V2500-A1/A5. SERIES PROPULSION SYSTEMS SERVICE BULLETIN

This document transmits the Revision 5 of Service Bulletin V2500-ENG-73-0186.

V2500-ENG-73-0186

ENGINE – FUEL AND CONTROL – EEC150-1/EEC150-20 PRESSURE BURNER SENSOR PORT SCREEN
DELETION

LOCATION OF THE ELECTRONIC ENGINE CONTROL
73-22-34
Figure 1

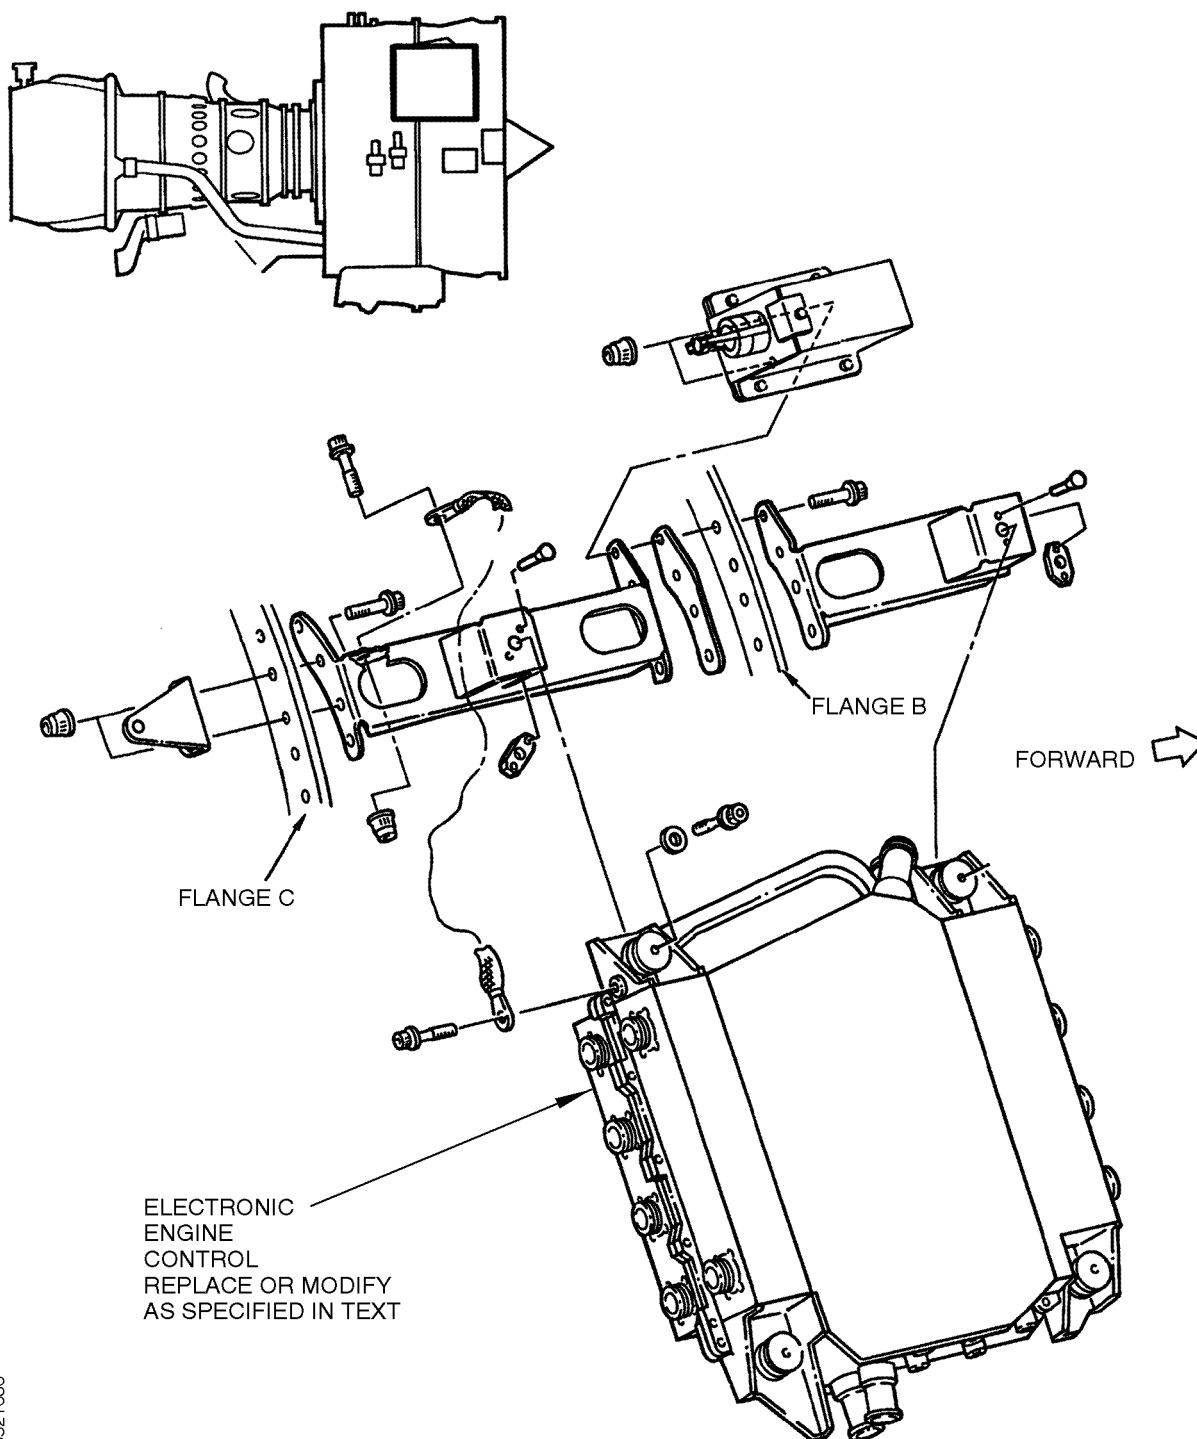
- (1) Remove the EEC as specified in Reference 9, Airbus Aircraft Maintenance Manual, Chapter/Section 73-22-34, TASK 73-22-34-000-010, Removal of the Electronic Engine Control (EEC) (4000KS). Refer to Figure 1 for the location of the EEC.
- (2) Replace the EEC with an already modified EEC from the list that follows. See Accomplishment Instructions, Part B of this Service Bulletin for EEC modification information.

- R (1) Replace the EEC with an already modified EEC from the list that follows.
See Figure 1 for the location of the EEC.

LOCATION AND REMOVAL OF THE PRESSURE BURNER SENSOR PORT
SCREEN BY AN OPERATOR
FIGURE 2, SHEET 1

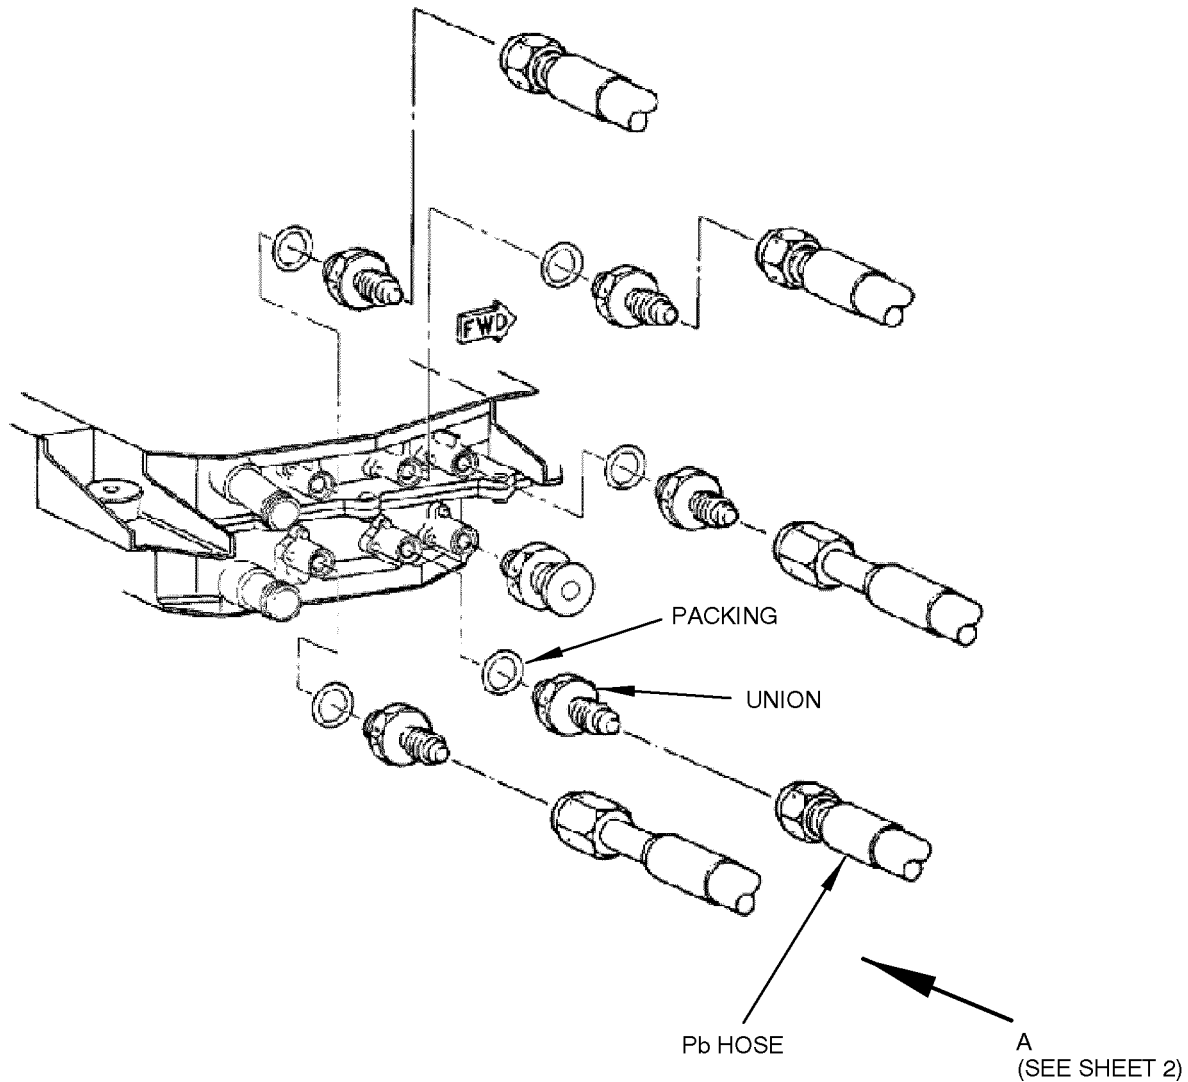
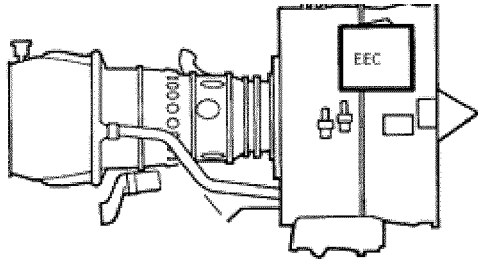
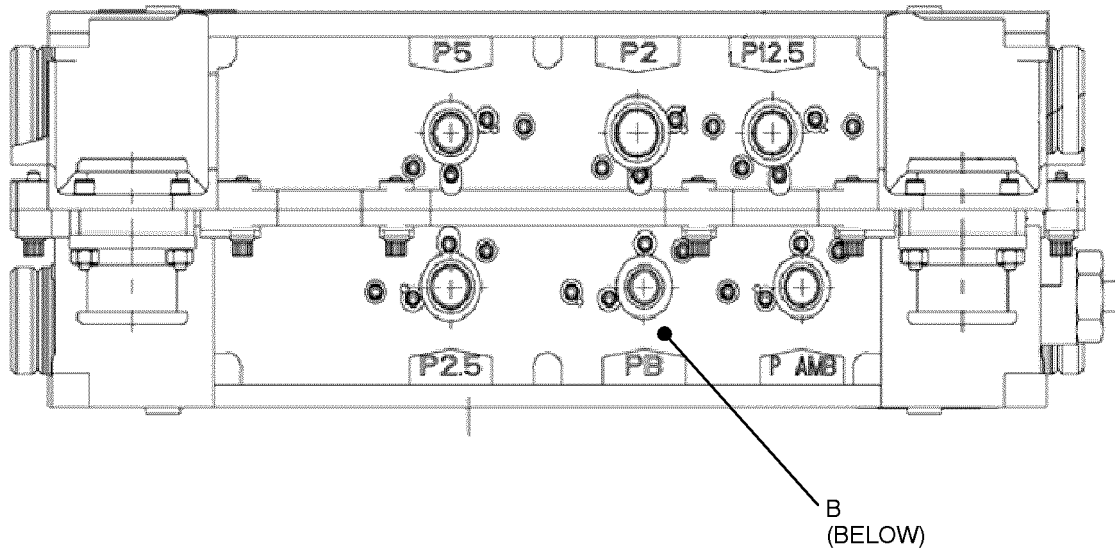
R (6) Remove the wire that safeties the Pb hose and union in Figure 2, Sheet 1.

R (22) Install a new Packing, PN NAS1595-4, shown in Figure 2, Sheet 1, onto the
R union. See Reference 9, Airbus Aircraft Maintenance Manual, Task
R 70-23-13-911-010.

LOCATION AND REMOVAL OF THE PRESSURE BURNER SENSOR PORT
SCREEN BY AN OPERATOR
FIGURE 2, SHEET 2

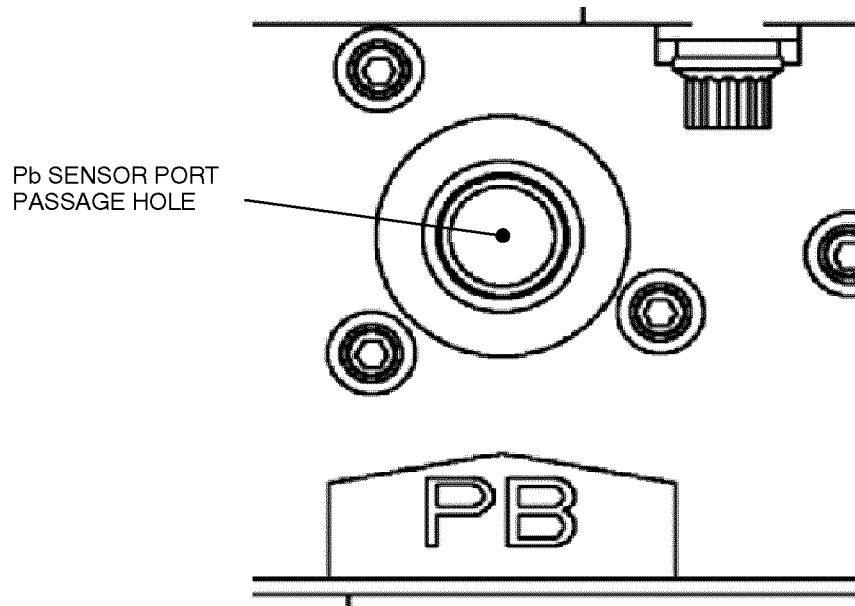
R (13) Locate the Pb sensor port passage hole. See Figure 2, Sheet 2 for the
R location of the hole.

R (14) Use a Snap-on® Pick, PN SG3ASH45BR or equivalent and approach the Pb
R sensor port passage hole with the pick point as close to passage center as
R possible. Pierce the center of the screen with the pick point while
R holding the pick at the required angle to orientate the pick point
R perpendicular to the screen. If necessary use a small light weight plastic
R tipped mallet to lightly tap the end of pick handle to initiate the screen
R piercing.

LOCATION AND REMOVAL OF THE PRESSURE BURNER SENSOR PORT
SCREEN BY AN OPERATOR
FIGURE 3, SHEET 2

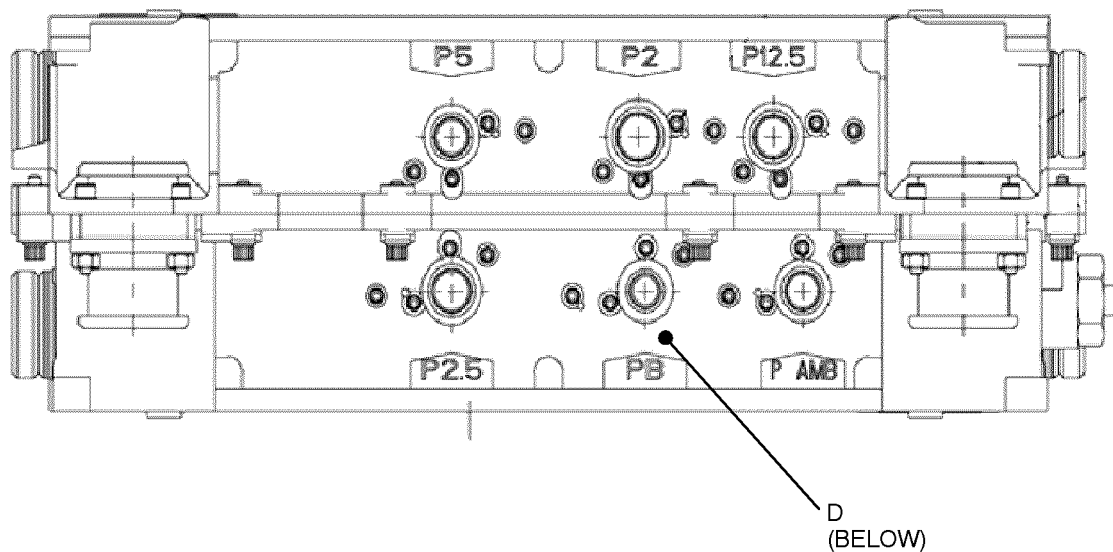
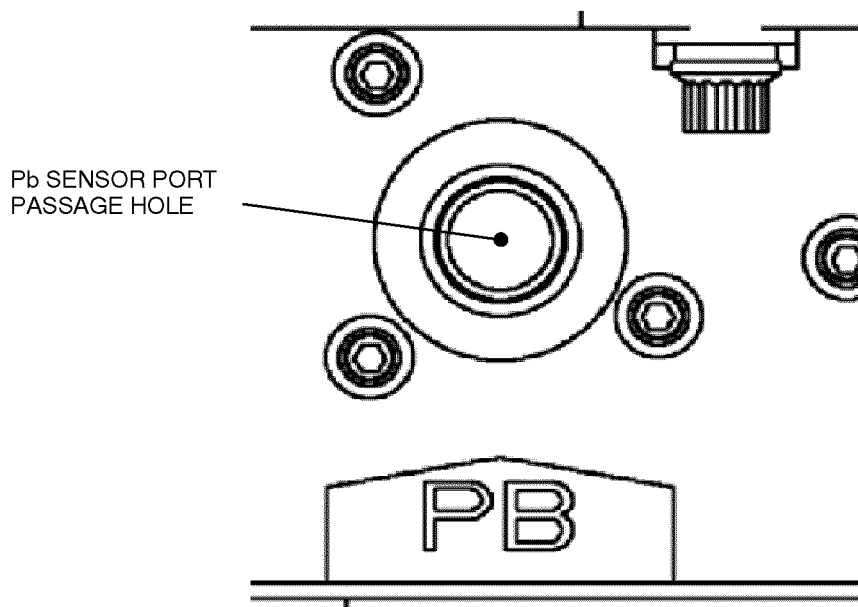
R (3) Locate the Pb sensor port passage hole. See Figure 3, Sheet 2 for the
R location of the hole.

R (4) Use a Snap-on® Pick, PN SG3ASH45BR or equivalent and approach the Pb
R sensor port passage hole with the pick point as close to passage center as
R possible. Pierce the center of the screen with the pick point while
R holding the pick at the required angle to orientate the pick point
R perpendicular to the screen. If necessary use a small light weight plastic
R tipped mallet to lightly tap the end of pick handle to initiate the screen
R piercing.
